**Tack Site, Sandyford SHD**

**Stage 1 Storm Water Audit**

**221140-PUNCH-XX-XX-RP-C-0001**

**March 2022**

PLAN VIEW – PROPOSED SURFACE WATER DRAINAGE LAYOUT AT PODIUM LEVEL

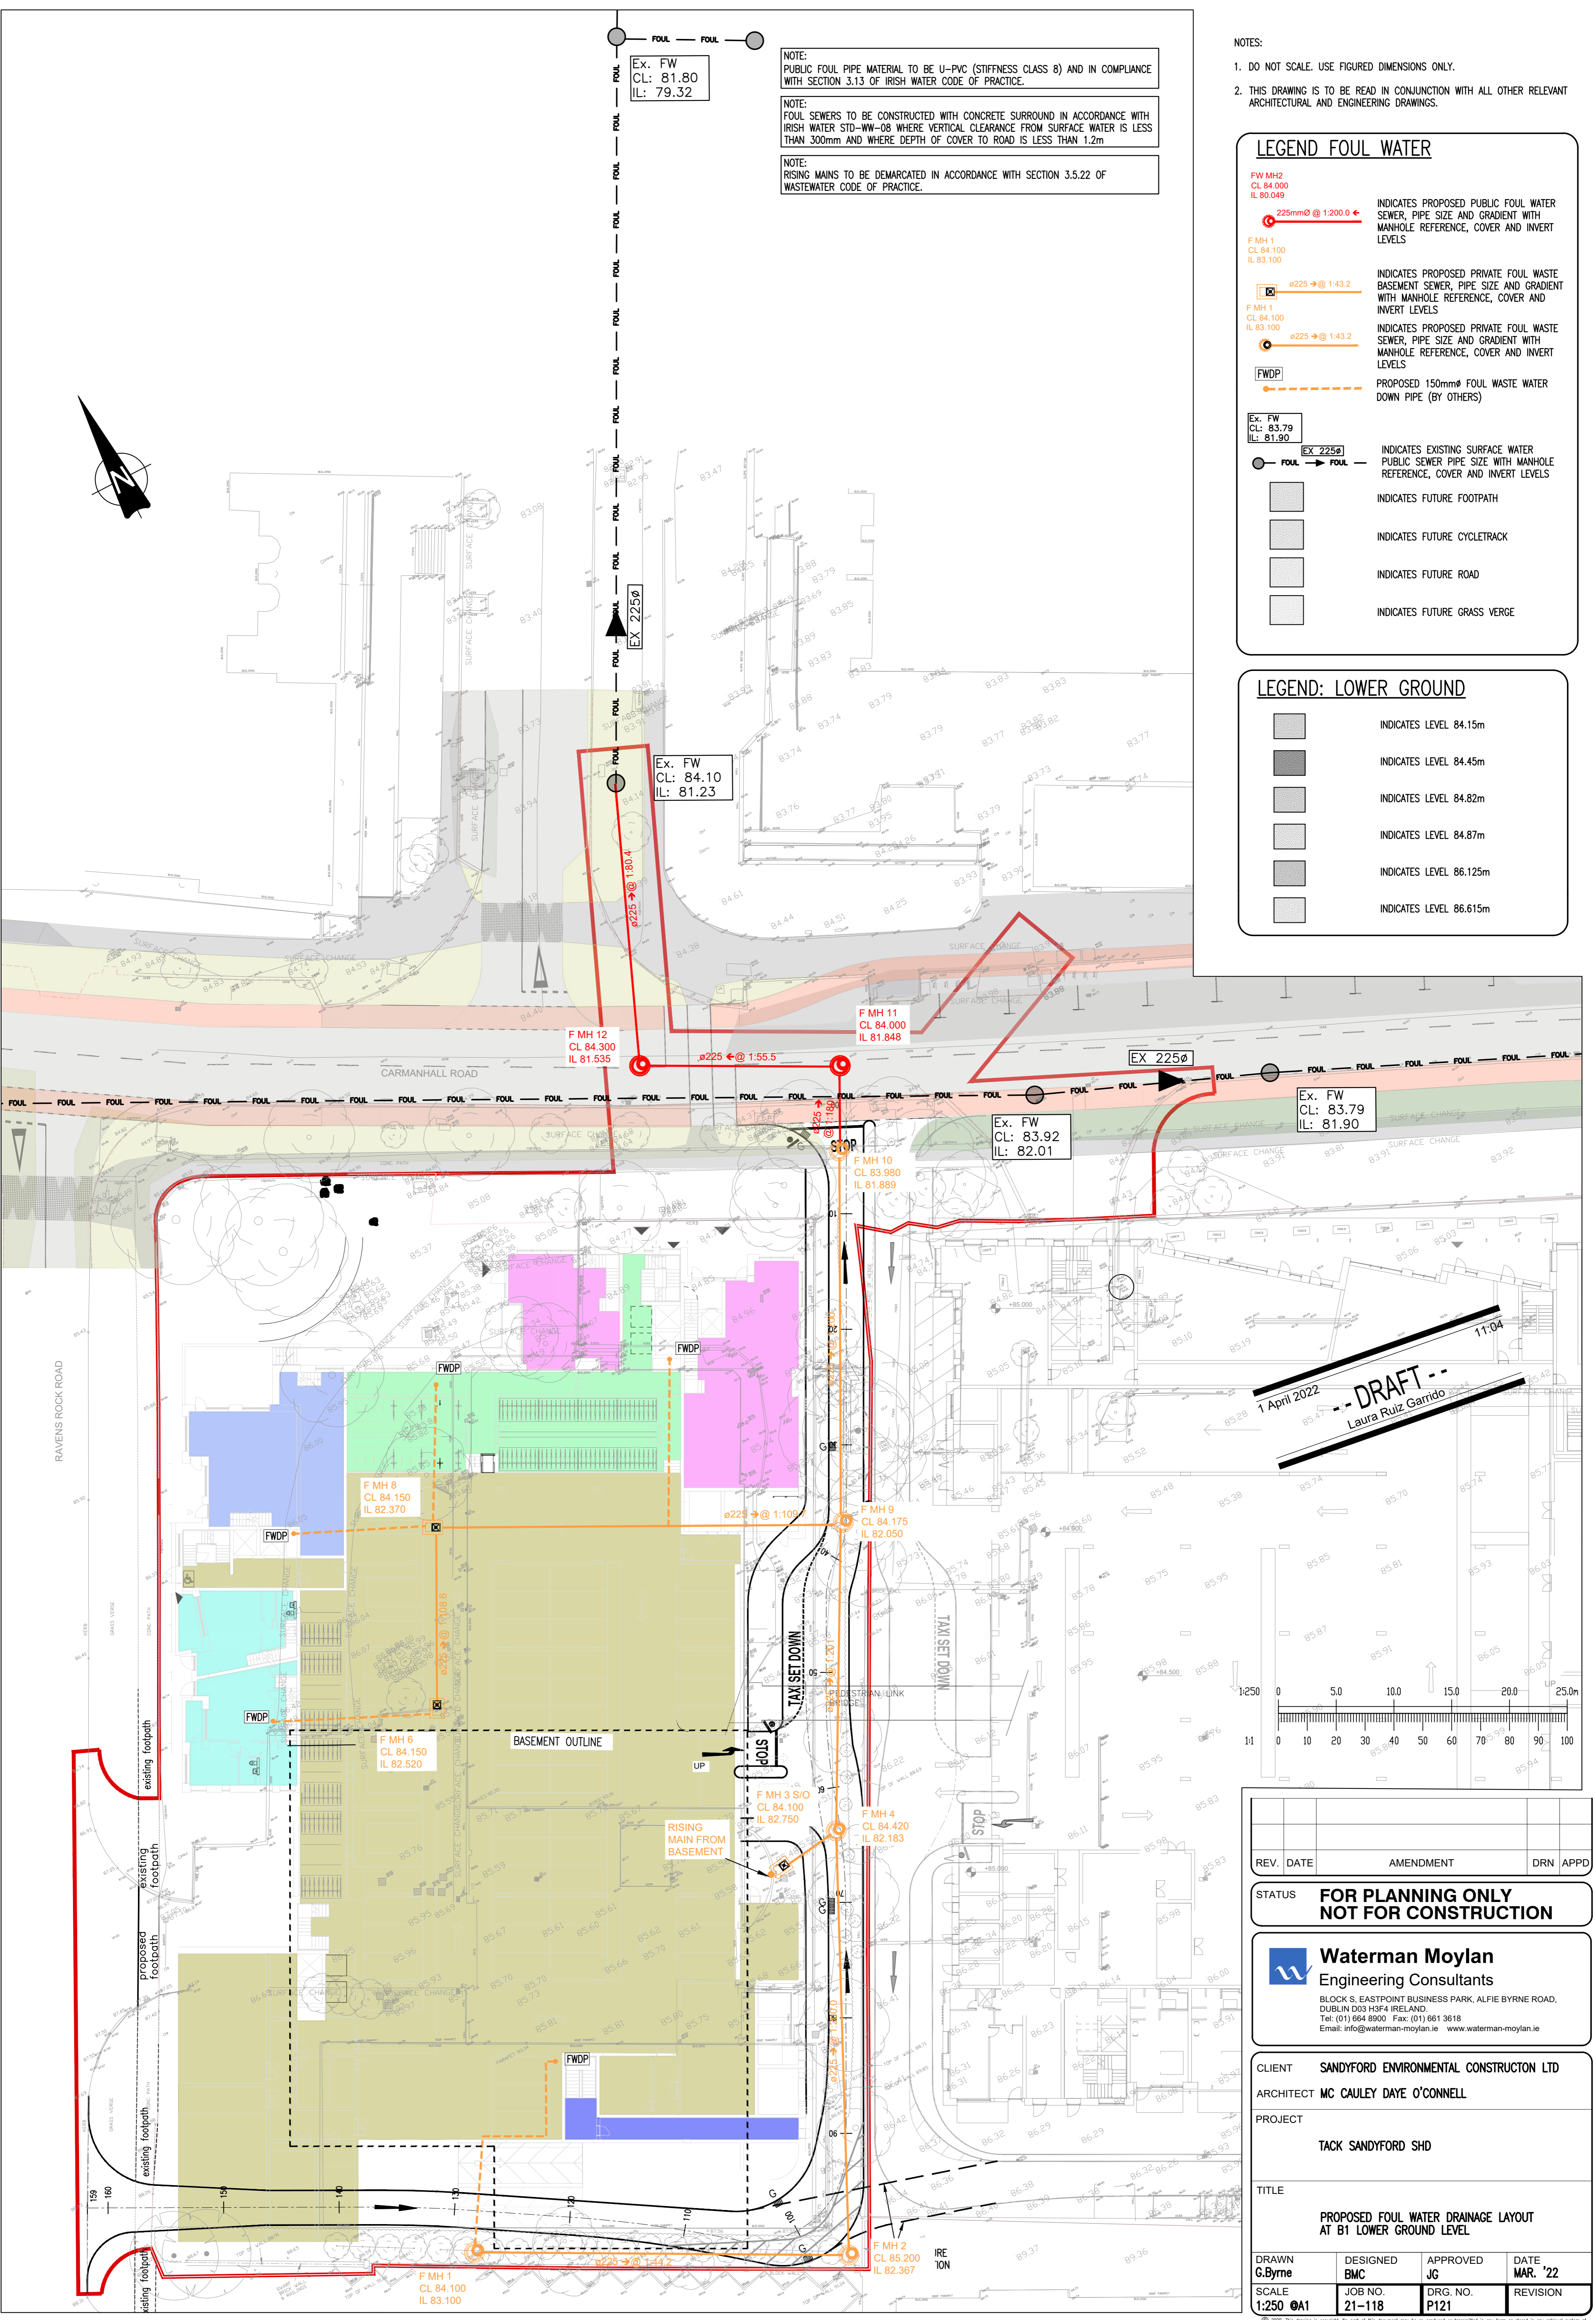
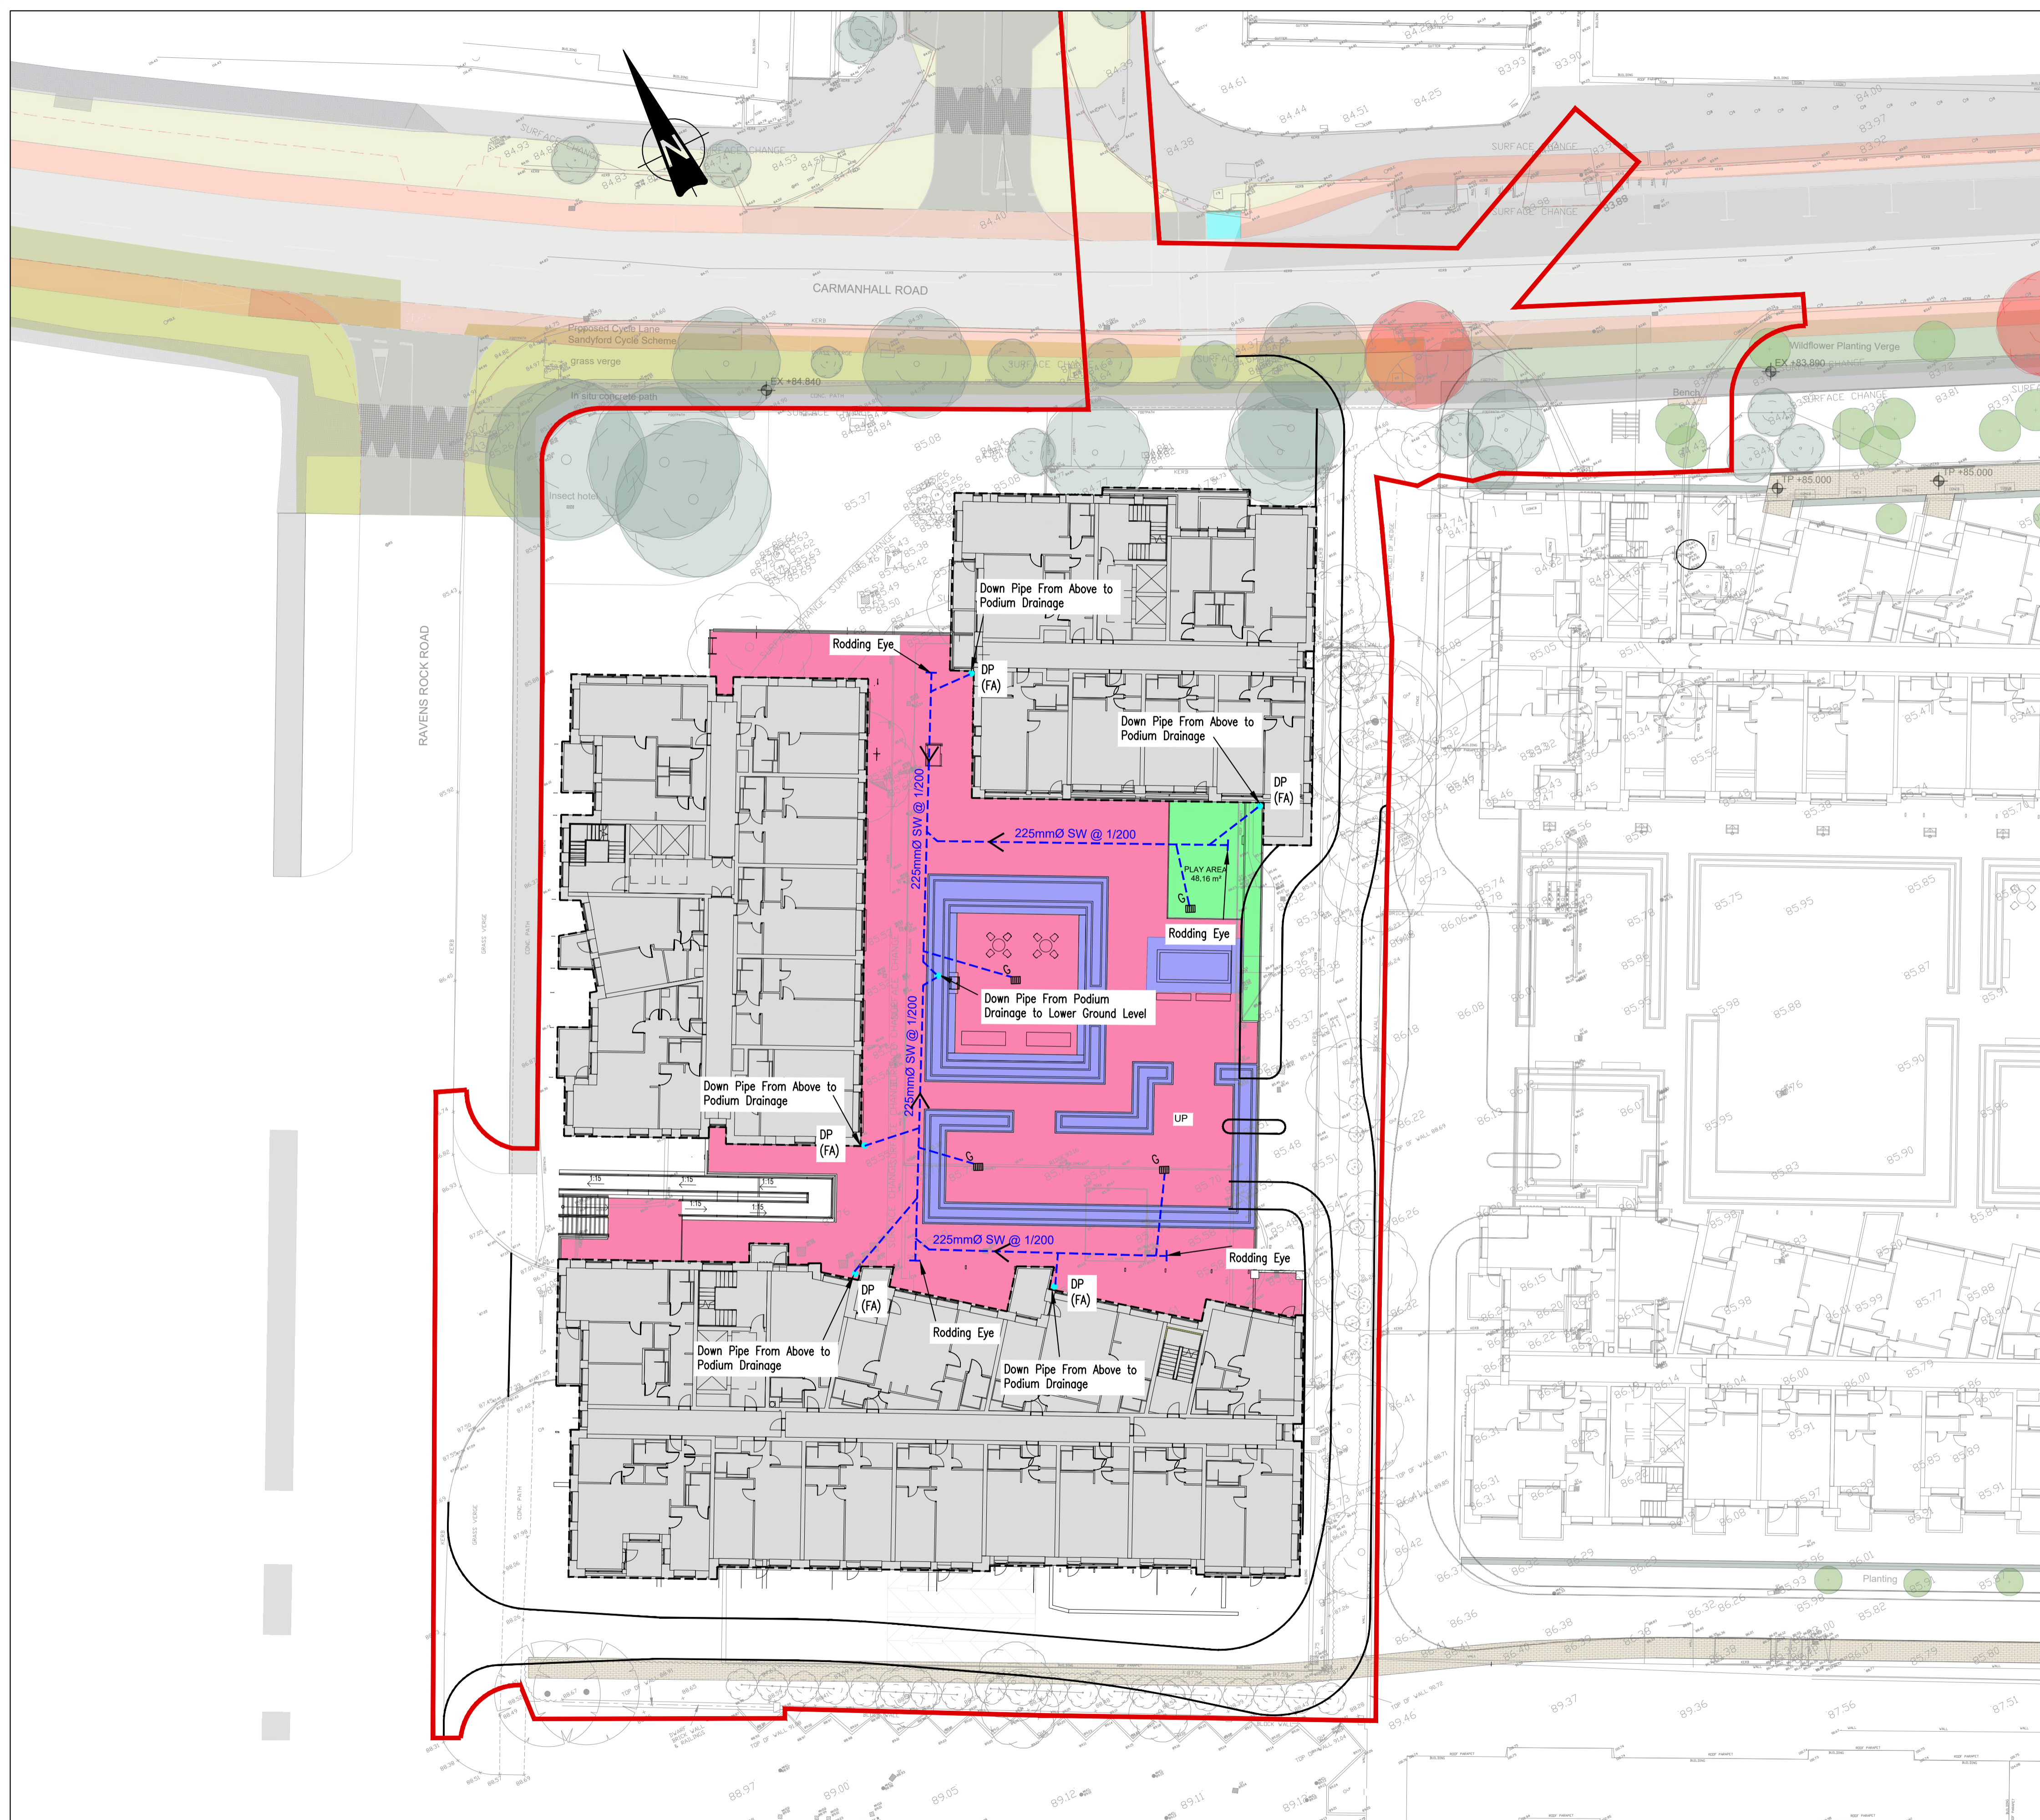
**Problem:** No proposals for the collection of surface water runoff from the under croft car park area have been shown (drawing P120).

**Recommendation:** Show proposals for collecting any runoff from the carpark including gullies etc. This should outfall via a petrol interceptor and then outfall to the foul network as per the Greater Dublin Regional Code of Practice.

2.1.1	Yes	Yes	Please refer to drawings P190 which shows an indicative layout with FFL for each of the levels to provide clarity.	
2.1.2	Yes	Yes	Refer to drawings P120, P121,P122, P123 and P124 showing the proposed car parking drainage at B1 lower ground level (undercroft car parking) and B2 Basement level.
